Re: Waiver request for 955 Trail Rd. North
 Lot Addition Plan, for Mark Kleinfelter
 AOA# 24-011

Exhibit A, Waiver Request
955 Trail Road North
Mount Joy Township
Lancaster County

Re: 955 Trail Road North
Waiver Request
LCEC Project No: 25-166

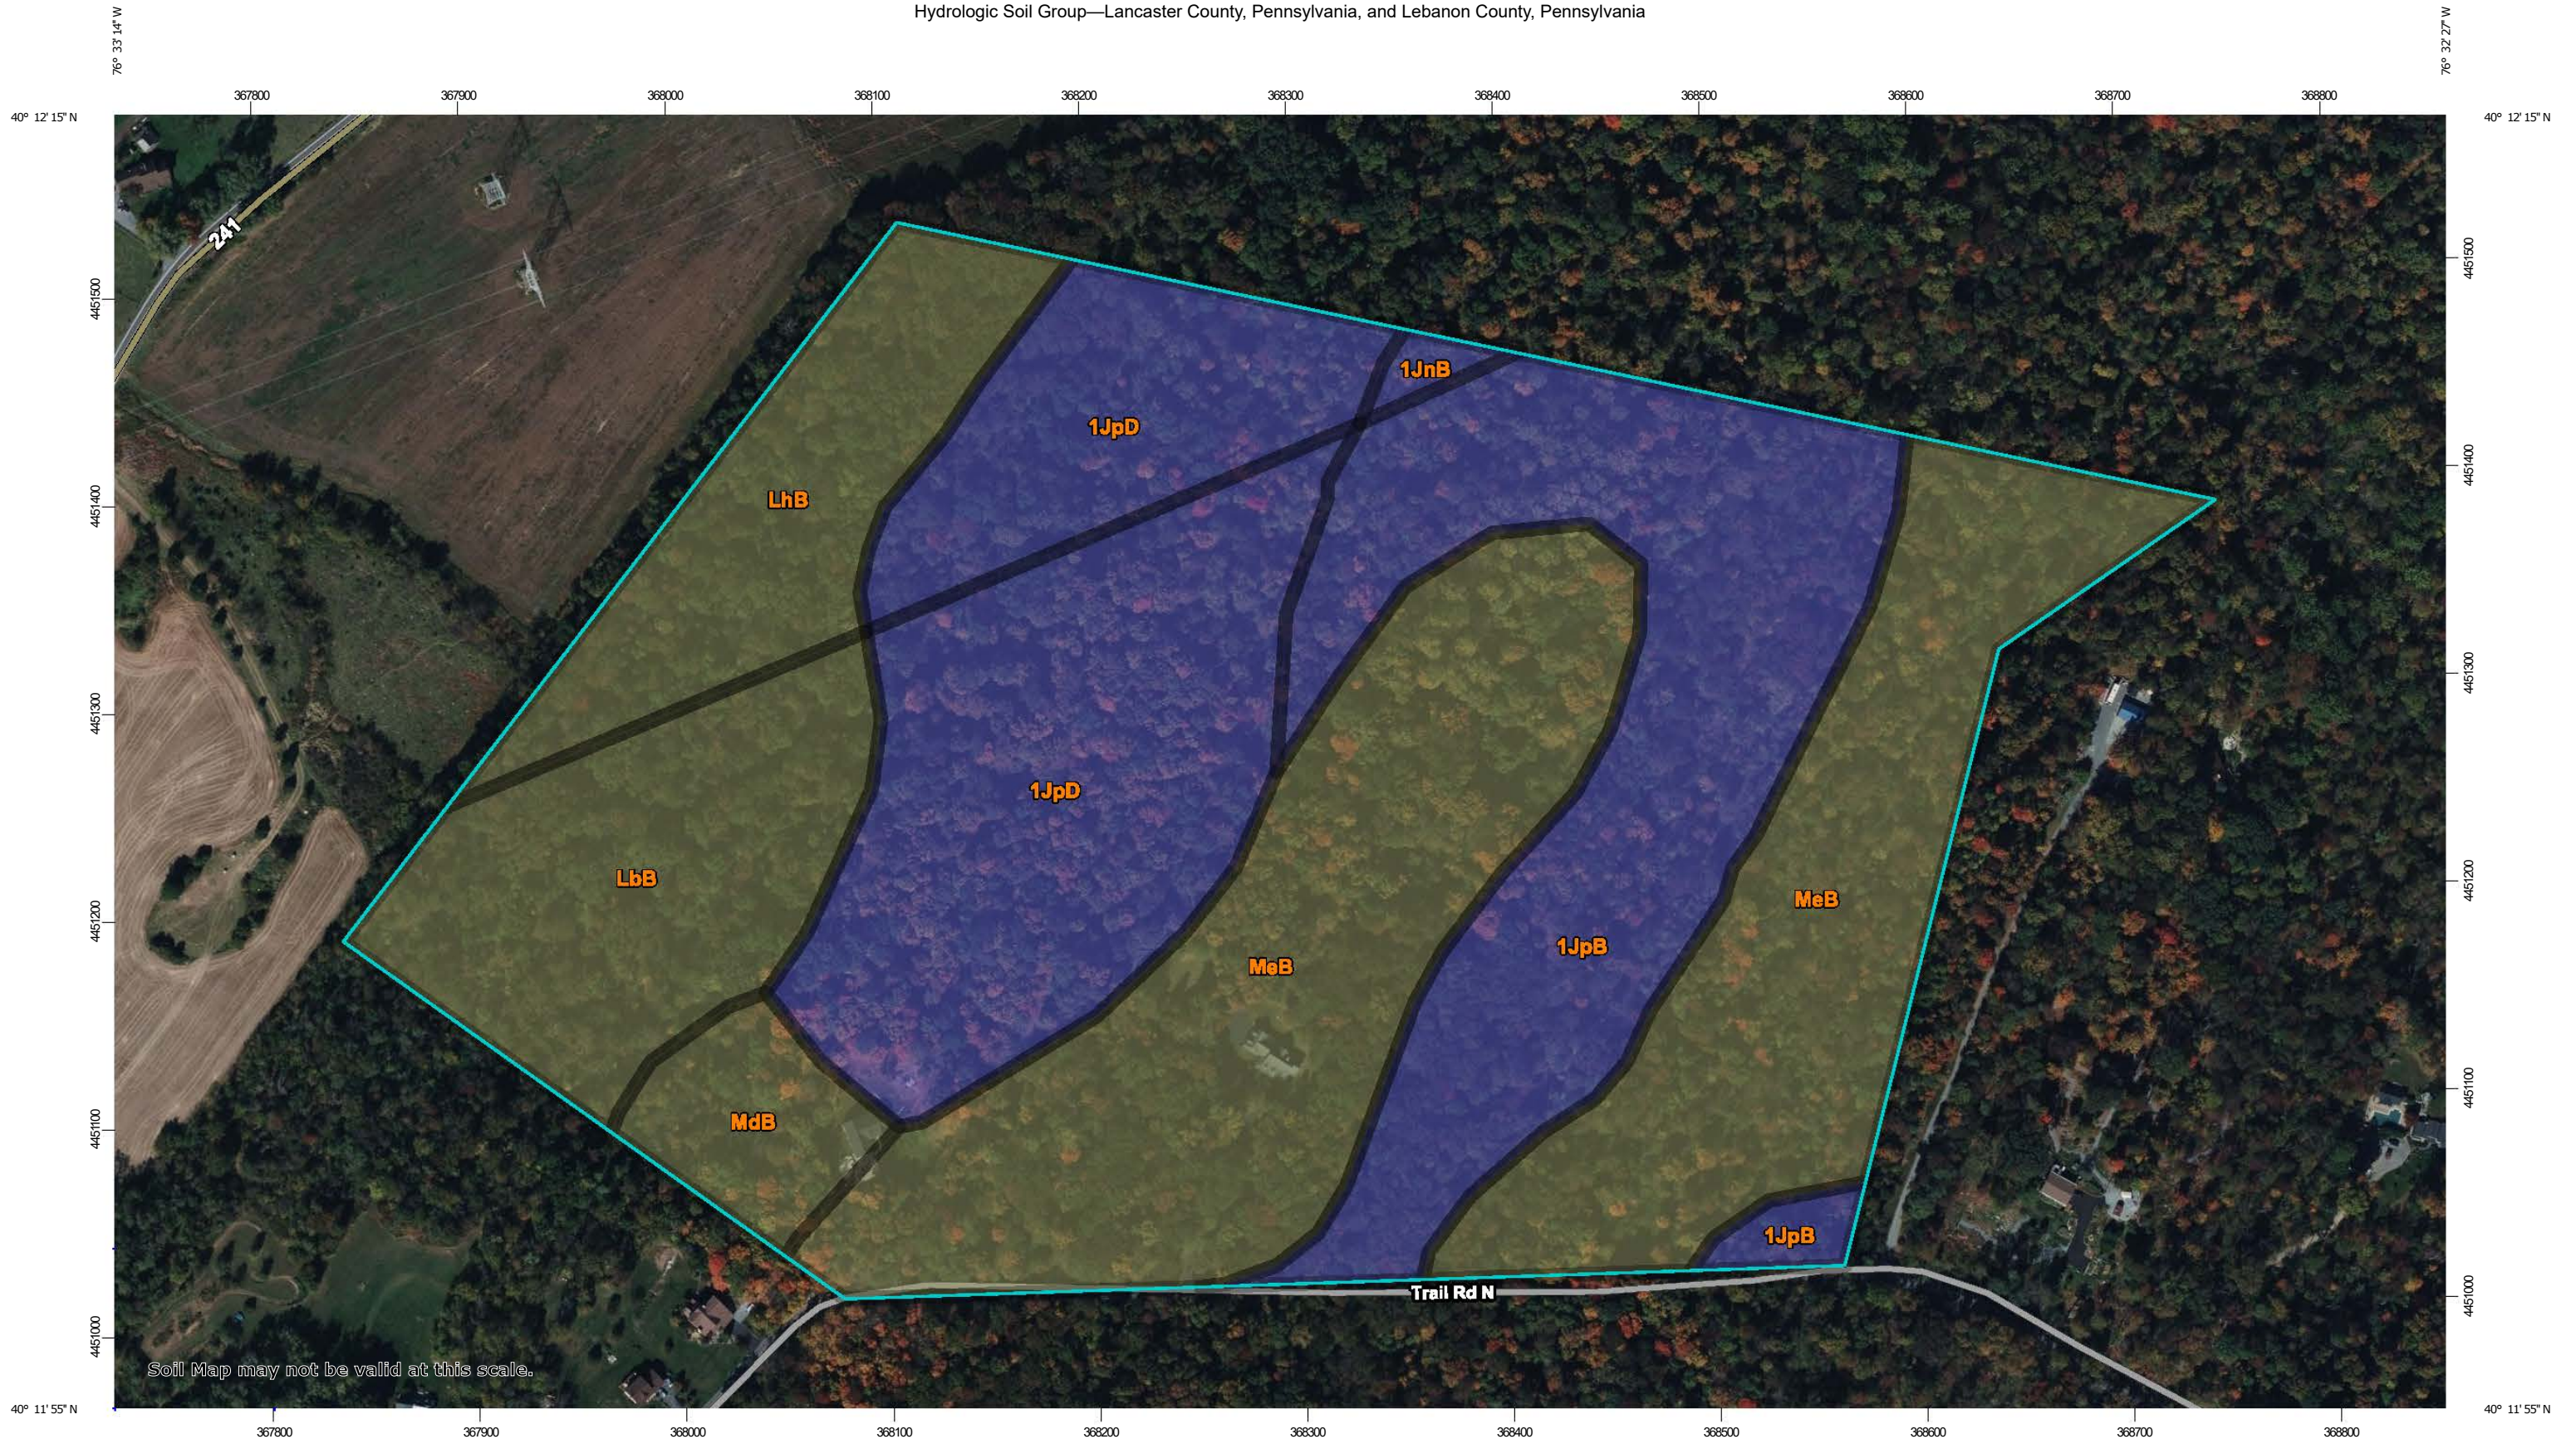
1. A 25 foot buffer surrounding the wetlands boundary shall be conserved (135-307.B). The applicant shall enter into a recordable agreement with the Township providing for the permanent maintenance of the wetland area, in a form acceptable to the Township Solicitor (135-307.E).

2. A wetlands study shall be provided (119-32.B). The applicant has requested a waiver of this requirement.

Waiver response: The recorded subdivision plan from 2002 shows three (3) wetland areas along Trail Road North. This is based on the 2001 Wetland and Soils Review which shows six (6) "possible wetland areas". (The 2002 plan only shows three out of the six possible wetland areas.) The wetland review specifically states that the review was not completed in accordance with the Army Corps of Engineers Wetland Delineation Manual.

In 2021 the Township applied for a DEP General Permit for the widening of Trail Road North. As part of that permit, Vortex Environmental performed a wetland investigation (dated May 28, 2021). This investigation also identified three (3) wetland areas along Trail Road North within the boundaries of these properties; however, the wetlands appear to be more extensive than those shown on the 2001 wetland review. This investigation was performed in accordance with the Army Corps of Engineers Wetland Delineation Manual.

As noted above, the Zoning Ordinance requires that the wetland area and the 25 foot buffer be conserved within a conservation easement. This requirement will need to be satisfied as part of the proposed lot line change plan. Providing an accurate, up-to-date wetlands study, that is performed in accordance with standard protocols, will be needed in order to identify the location of the wetlands that will be included within the conservation easement. Based on these considerations, I am not able to support this modification.
